CPED STAFF REPORT

CPC Agenda Item #3
July 28, 2014
BZZ-6417

Property Location: 312 Lake Street West
Project Name: Karmel West
Prepared By: [Brad Ellis](#), Senior City Planner, (612) 673-3239
Applicant: Karmel West, LLC
Project Contact: Rochelle Barrett
Request: To construct a second story addition above an existing commercial building.
Required Applications:

Site Plan Review	For a 42 foot by 75 foot second story addition with a 25 foot by 42 foot covered roof deck fronting Lake Street West.
-------------------------	---

A1 SITE PLAN 2974 GRAND / 312 WEST LAKE
1:20

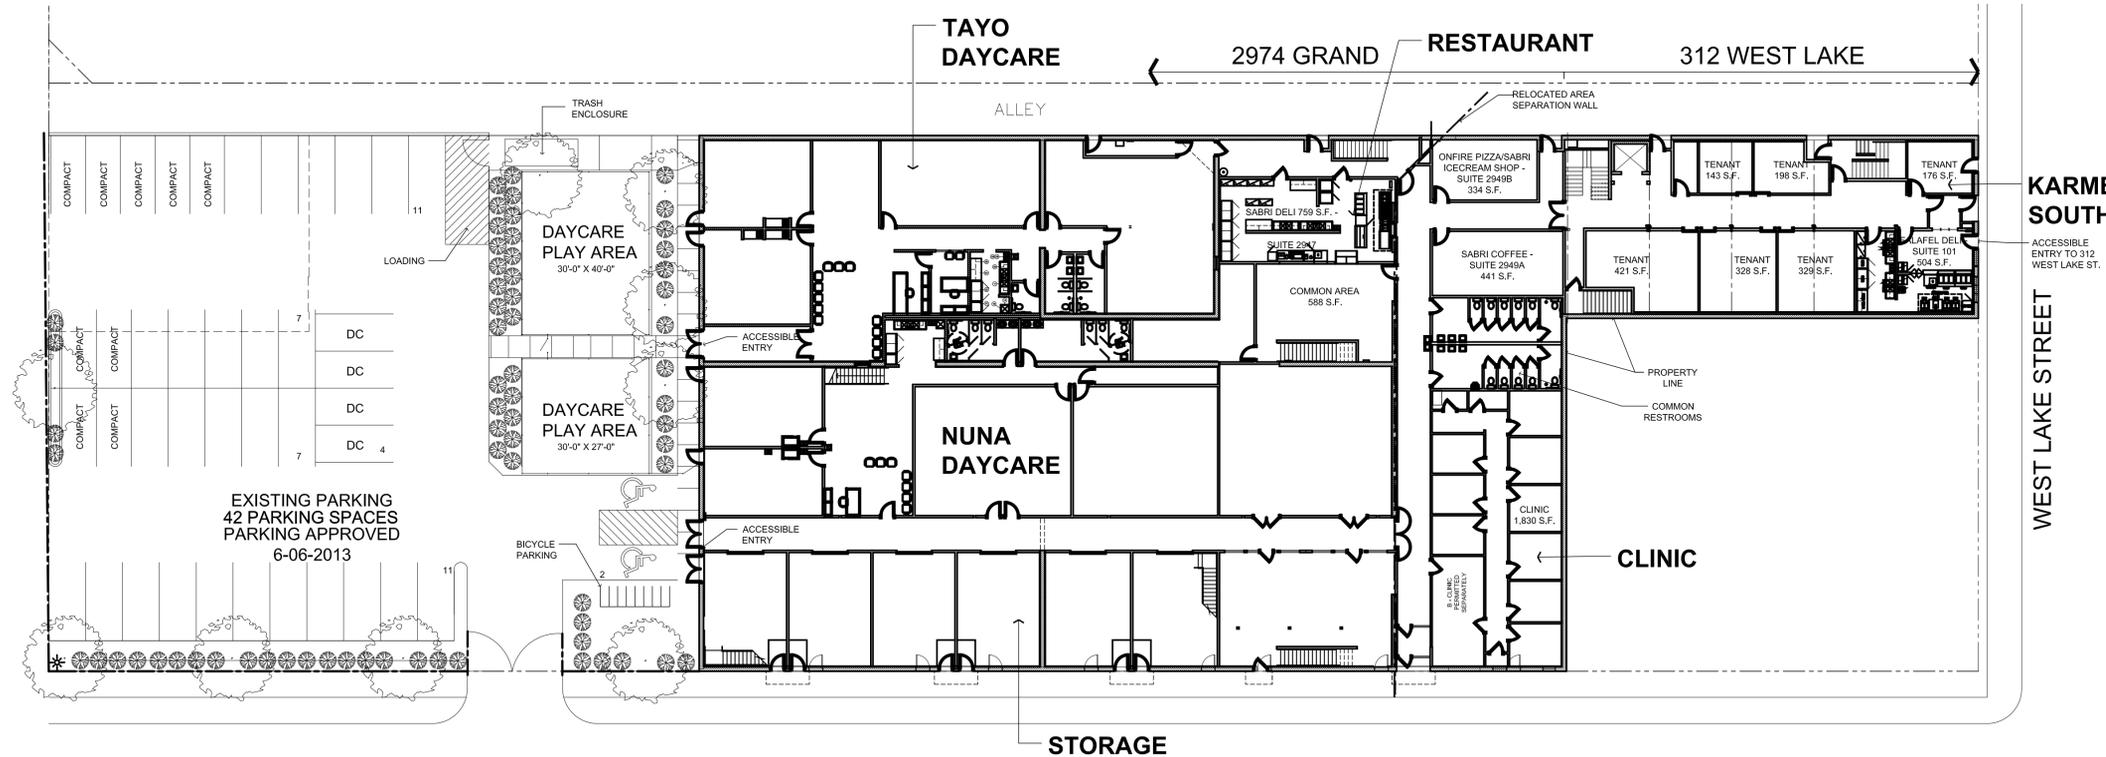
- The zoning code requires that at least 20 percent of the site not occupied by the building be landscaped. Per City records, the lot area of the site is 47,236 square feet. The applicant is showing a lot area of 47,040 square feet. The footprint of the building is 28,590 square feet, resulting in a net lot area of 18,646 square feet. Twenty percent of the net lot area is equivalent to 3,729 square feet. The applicant is proposing 2,326 square feet, or 12.5 percent of the site. The applicant is also proposing two children’s play areas for a total of 1,950 square feet of play area.

- Staff is recommending alternative compliance to the 20 percent landscaping for the children’s play areas. Together these would total 4,276 square feet, or 22.9 percent. Staff is recommending that the children’s play area be a permeable material to allow for infiltration.

Based on the proposed uses, a shared parking agreement will reduce the requirements from 53 + 6 drop off spaces to 48 + 6 drop-off spaces. 42 spaces are provided. The applicant is proposing to utilize the bicycle parking incentive to receive a 10 percent reduction in number of required automobile spaces, reducing the number of required spaces by six (6) to a total of 42 plus 6 drop-off spaces. The applicant may provide the drop-off spaces on the street with approval from the City engineer. Staff is recommending a condition of approval that the applicant complete a Reducing Off-Street Parking Requirements application and obtain approval from the city engineer for the drop-off spaces.

Staff is recommending a condition of approval to provide a bike rack(s) that can accommodate a minimum of 21 spaces in order to meet the minimum requirement and benefit from the bicycle incentive to reduce automobile parking spaces.

3. Completion of a Reducing Off-Street Parking Requirements application to meet the parking requirement on-site, to include the provision of bicycle racks to accommodate no fewer than twenty-one (21) bicycles on the property that shall meet the minimum requirements for short term bicycle parking.

5. The play areas shall be pea gravel over soil or other permeable surface.
6. Refuse storage containers shall be screened on all four sides by screening compatible with the principal structure not less than two (2) feet higher than the refuse container.

A3 PROPOSED WEST ELEVATION W/ NEW SECOND FLOOR CANOPY
 3/32" = 1'-0"

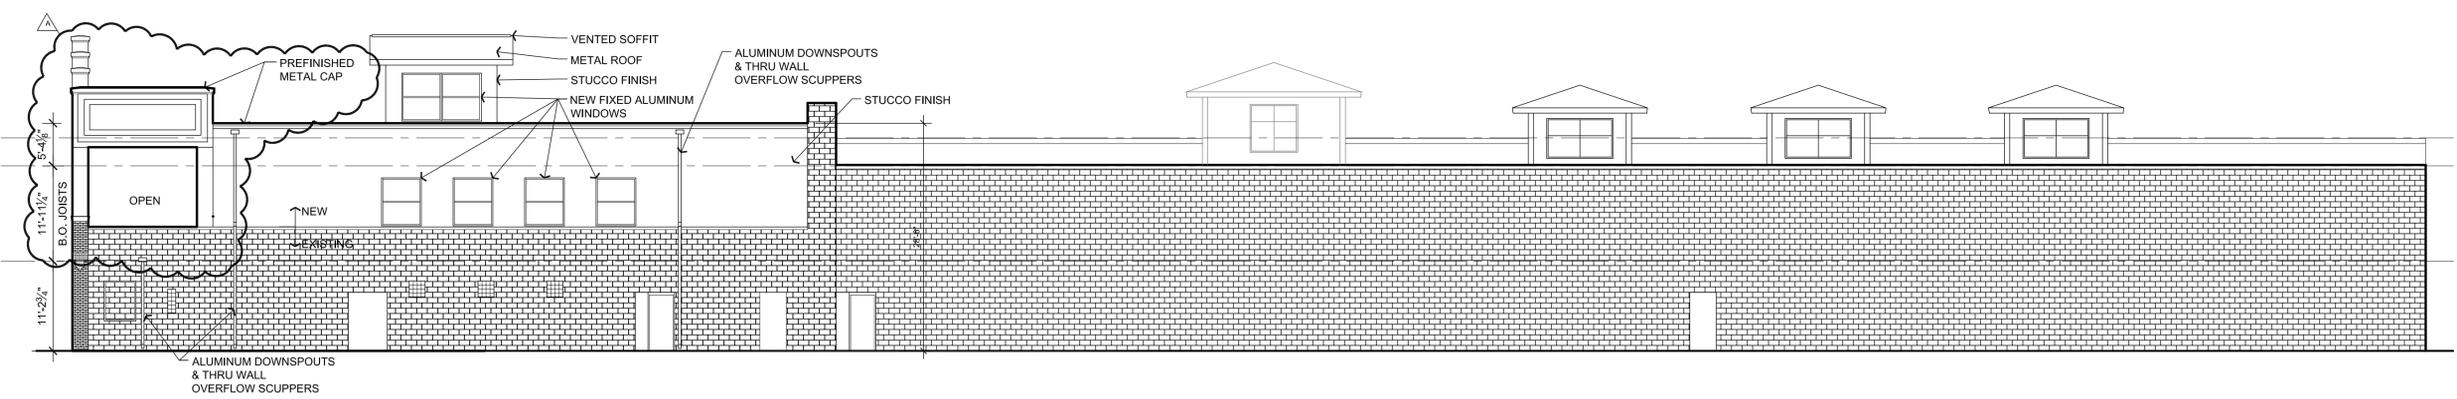
- **Blank, uninterrupted walls shall not exceed 25 feet in length.** Alternative compliance is requested for the maximum 25 foot length of blank, uninterrupted walls along the west elevation of the addition. The western elevation is along the property line of 318 Lake Street West, and the building code does not allow openings within three feet of a shared property line. There is also the potential for redevelopment of the 318 Lake Street West site, which would obscure any architectural details on the addition at 312 Lake Street West. Staff recommends alternative compliance be granted.

7. The parapet shall be flat and shall extend no higher than forty-two (42) inches above the roof.
8. The applicant shall provide proof of easement for the mechanical equipment on the west façade of the addition or shall be required to move it to the interior.

A1 PROPOSED SOUTH (LAKE STREET) ELEVATION W/ NEW 2ND FLOOR CANOPY
 3/32" = 1'-0"

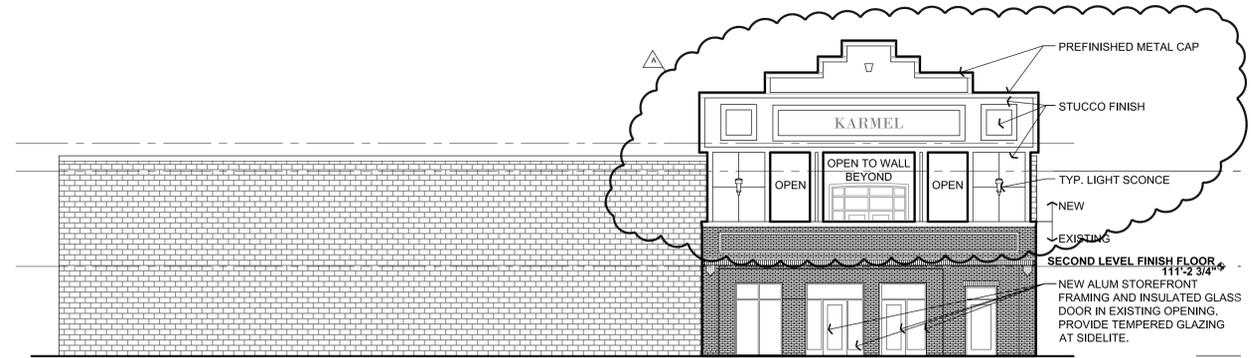
- The structure has a flat roof similar to other structures in the area; however the building façade has an unusually large parapet that is not in keeping with the form and pitch of surrounding buildings. Staff is recommending a condition of approval requiring the removal of the extended parapet.

- **Form and pitch of roof lines shall be similar to surrounding buildings.** Alternative compliance is requested for the 11 foot tall pyramid parapet above the addition. The parapet is not in keeping with the form and pitch of roof lines in surrounding buildings. Staff is recommending alternative compliance not be granted, and that a condition of approval be placed requiring the removal of a substantial portion of the parapet in order to comply with this requirement.
